# Access Compliance Report

## Public Rights-of-Way

### (Curb Ramps)

Intersection ID: 11745	Main Street: E_19TH_ST	Cross Street: HARRILL_ST	Location: E
ADA ID: 5DB1482A763D	Ramp Type: PerpDiag	Initial Pass/Fail: Fail	Overall Compliance: No
			Severity Score: 21.25

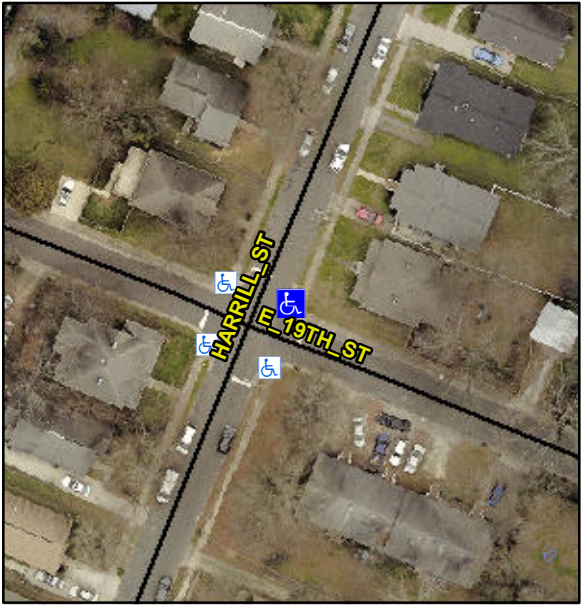
Codes/Mitigation Info/Possible Solution			Field Measurements/Component Compliance		
	Possible Solutions:		<b>Compliance</b>	<b>Description</b>	<b>Data</b>
	<b>Remove &amp; Replace Curb Ramp With Two New Directional Ramps or Equivalent.</b>		N/A	Ramp Length (in)	52.0
			No	Ramp Width (in)	36.0
			N/A	Flare Type LT	N/A
			N/A	Flare Slope LT (%)	N/A
			N/A	Flare Traversable LT?	N/A
			N/A	Landing Length (in)	N/A
			N/A	Landing Width (in)	N/A
			N/A	Landing Slope (%)	N/A
			N/A	Landing X Slope (%)	N/A
<p>Surveyor Notes:</p> <p><b>N/A</b></p> <p>PROW/ADA:</p> <p><b>R304.5.1, R304.5.3</b></p>			N/A	Flare Type RT	N/A
			N/A	Flare Slope RT (%)	N/A
			N/A	Flare Traversable RT?	N/A
			N/A	DWS Provided?	N/A
			N/A	DWS Contrast?	N/A
			N/A	DWS Length (in)	N/A
			N/A	DWS Full Width?	N/A
			N/A	DWS Offset (in)	N/A
			N/A	Gutter Ponding?	N/A
			N/A	Gutter Lip Ht (in)	N/A
			N/A	Painted X Walk1?	No
				X Walk 1 Direction	To NW

N/A	X Walk 1 Width (in)	N/A
				X Walk 1 Slope (%)	2.6
				X Walk 1 X Slope (%)	5.1
			N/A	Ramp inside XWalk1?	N/A
				Road Slope (%)	3.4
				Road X Slope (%)	6.0
			N/A	Any Obstructions?	N/A
				Obstruction Type	
Total Cost:		\$ 3200.00			
			N/A		N/A
			Yes	Surface Condition? (G/P)	Good
